Wayland High School

COMMENTS FOR RELOCATING PUBLIC PARKING LOT

COMMENTS REGARDING SOFTBALL FIELD

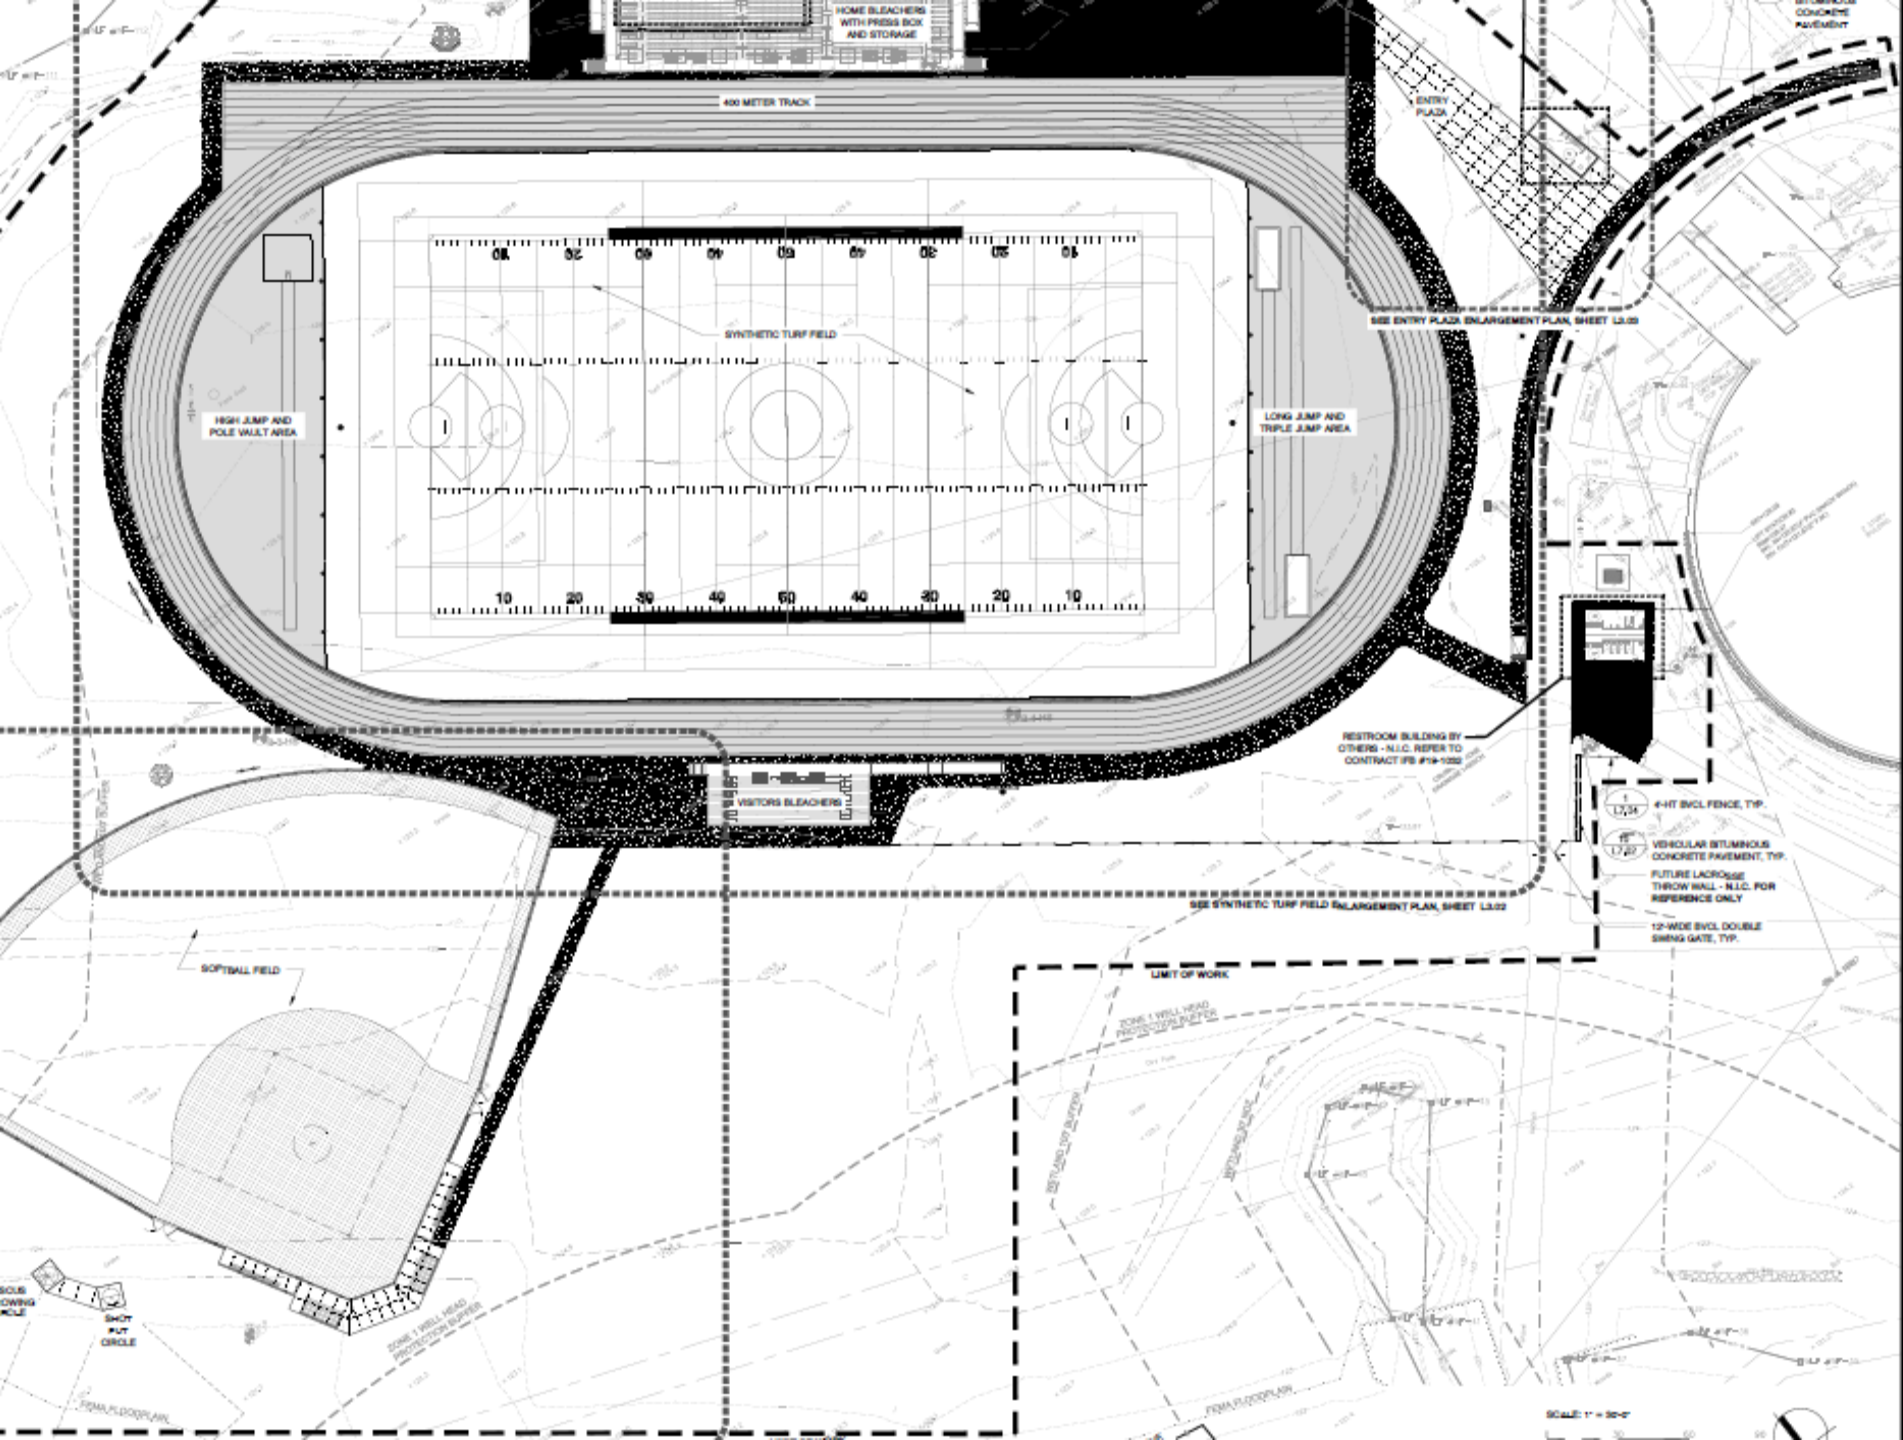
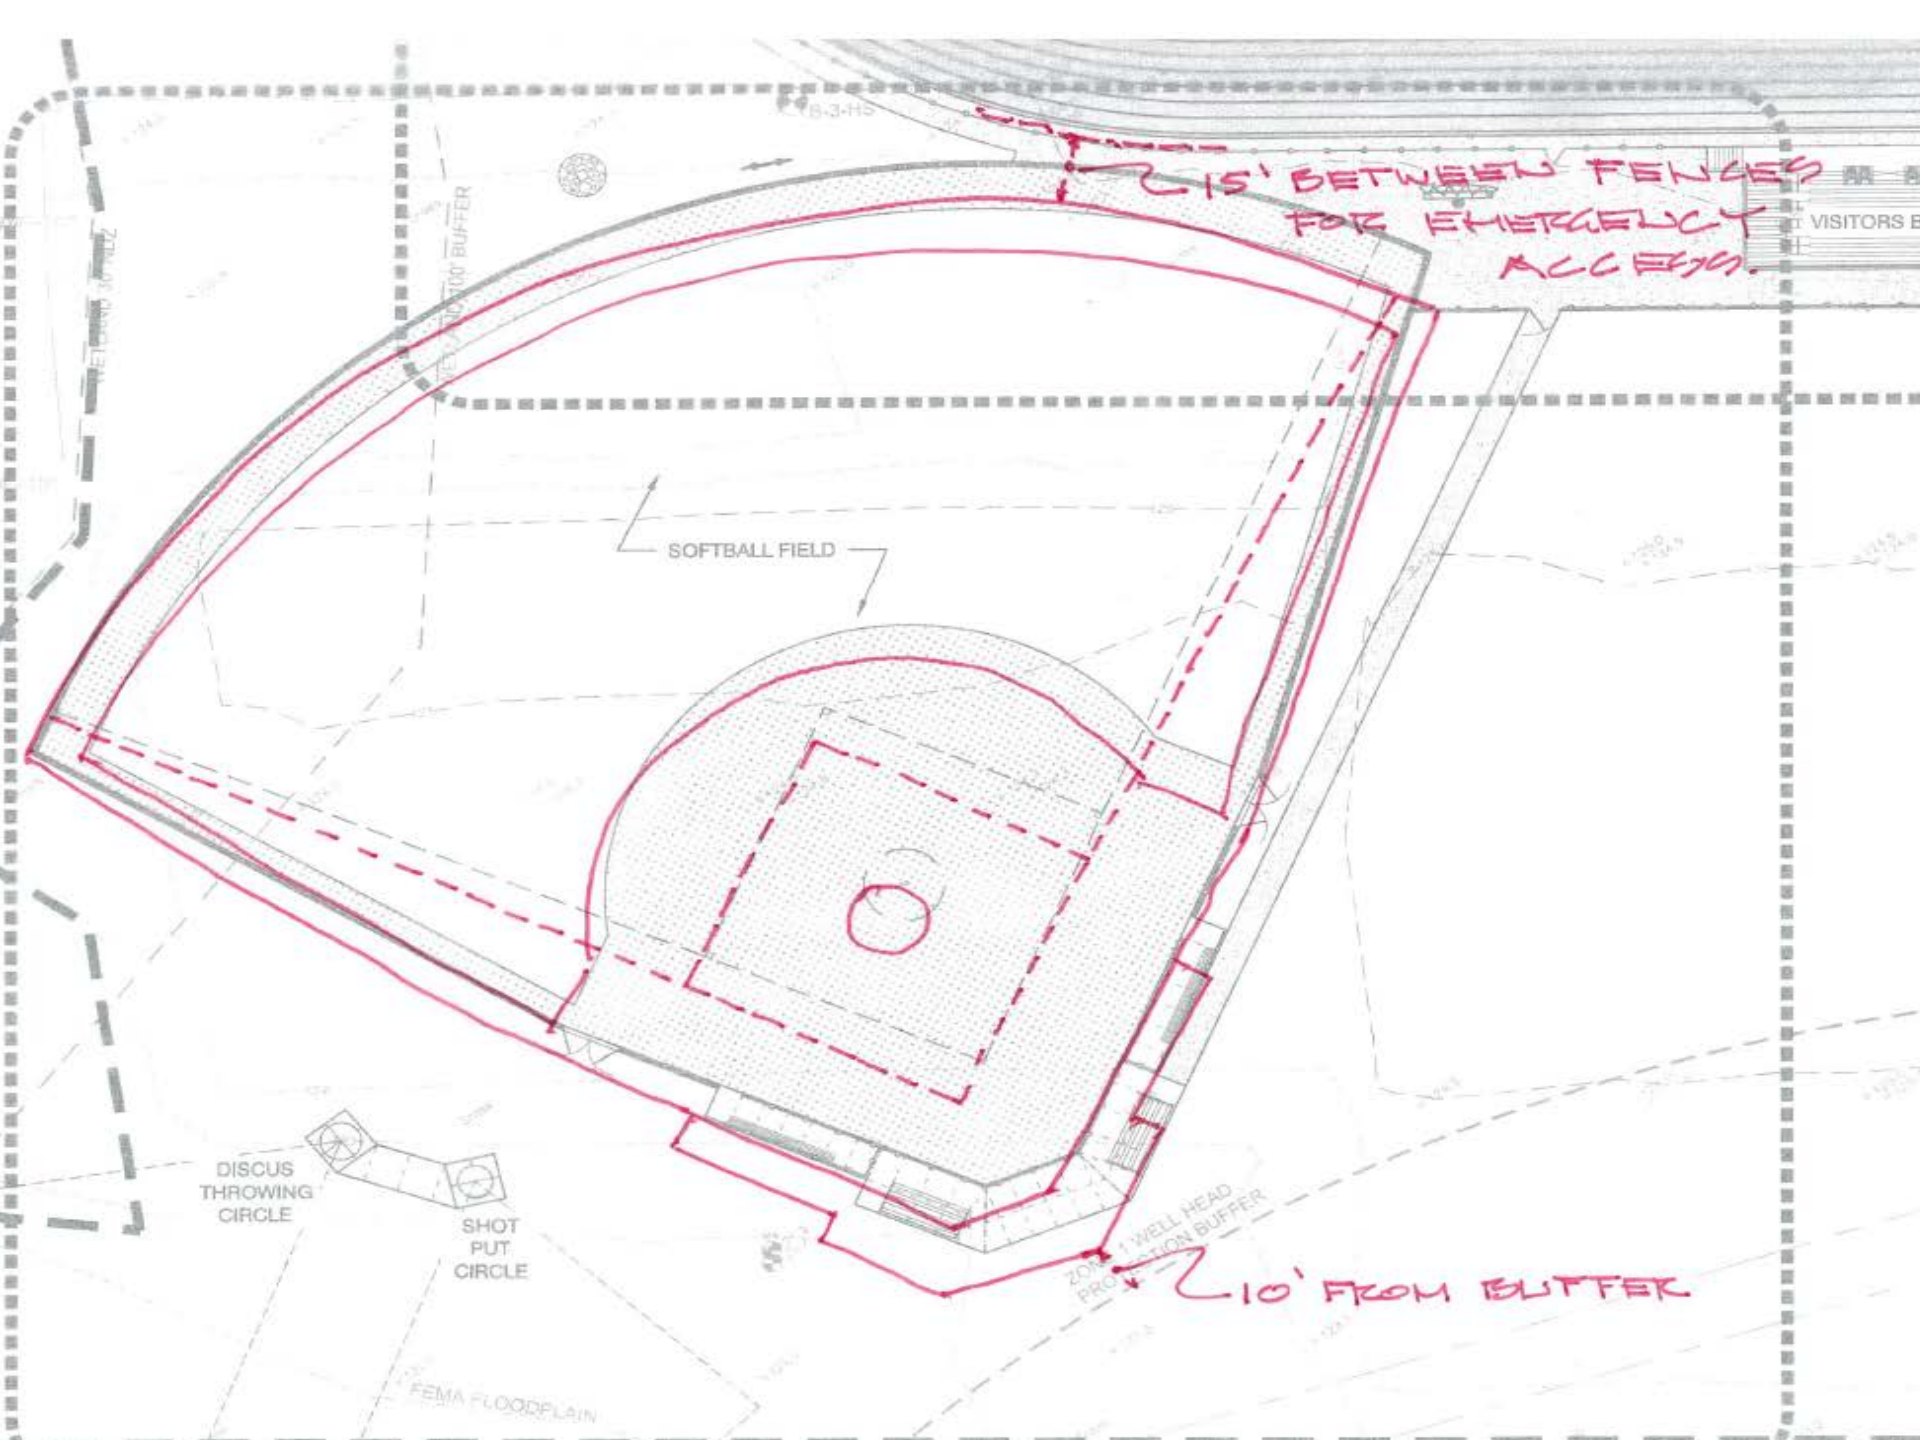
- Entrance / exit to public parking would have an increased 'ease of access' if located directly off Old Connecticut Path and not off the main entry drive to the school especially when school is letting out.
- Parking lot should be expanded if relocated (to the south) to about 45 spaces and its location would also serve the Weston Aqueduct Trail
- Fencing and Lighting for all the courts (Tennis and Basketball) could be consolidated and simplified to reduce overall costs and to reduce the visual impact.

- Wherever possible emergency access should be provided throughout the entire facility. If the field location were to shift slightly west by 10+/- feet, it would provide a 15' wide opening between the outfield fence and the track fence.
- Softball field is replacing 4 tennis courts creating a large reduction in hard surface area which is in close proximity to wellhead protection buffer. The reduction should offset shifting the backstop fence to within 10' of the protection buffer.
- 15' space between fencing is more appealing as a pedestrian passage as well as allowing emergency access.
